Intel[®] Atom[™] Processor E6xx Series

Specification Update

July 2014

Revision 017

Figure 10. 1U Natural Convection Heatsink Mechanical Drawing

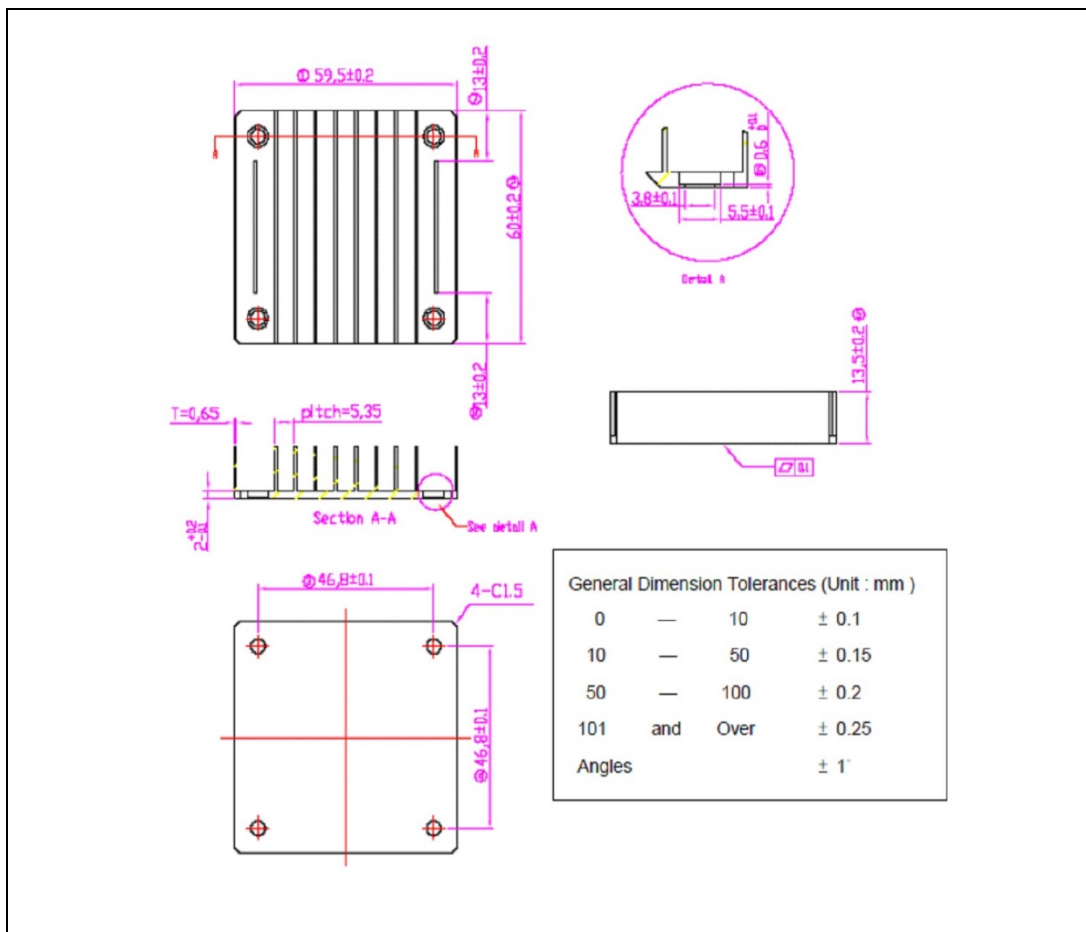
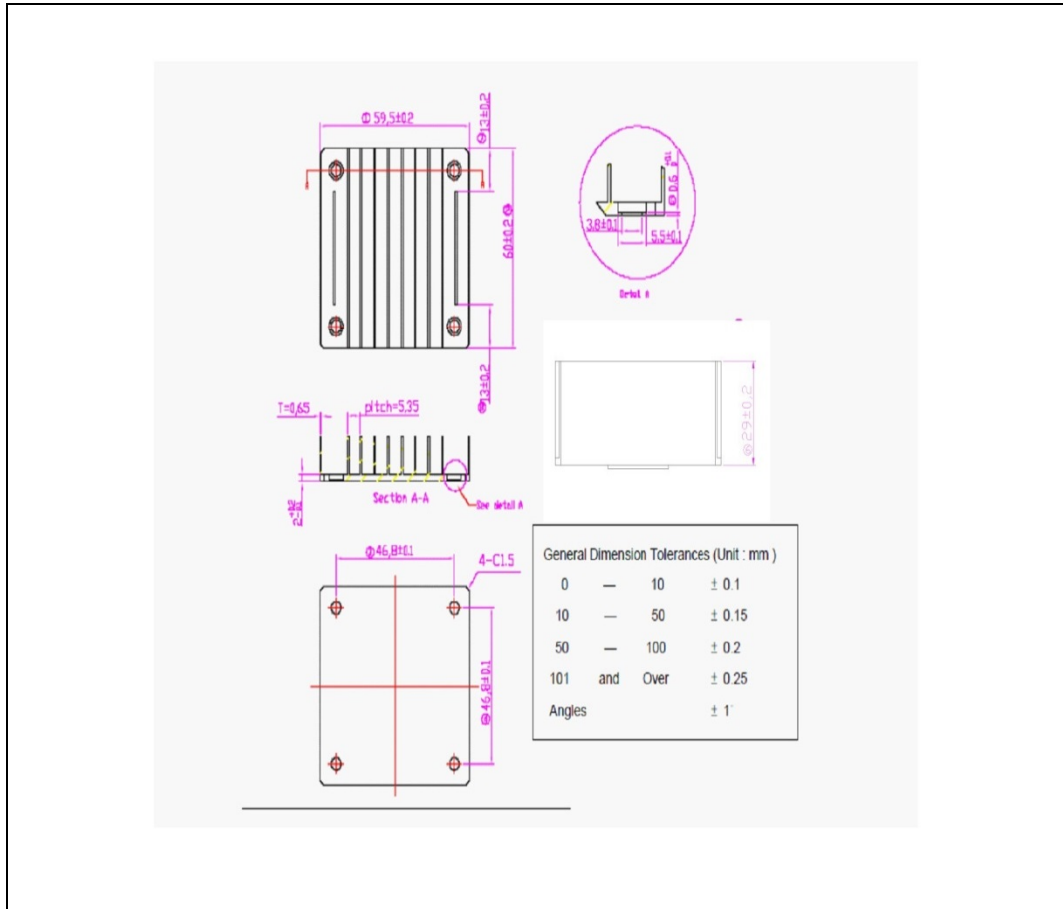
1. Heatsink Height Change

Issue: Heatsink height on Figure 10 “1U Natural Convection Heatsink Mechanical Drawing” has changed from 13.5 ± 0.2 mm to 29 ± 0.2 mm.

Affected Docs: Figure 10 “1U Natural Convection Heatsink Mechanical Drawing” of *Intel® Atom™ Processor E6xx Series Thermal and Mechanical Design Guidelines, Rev 003*.
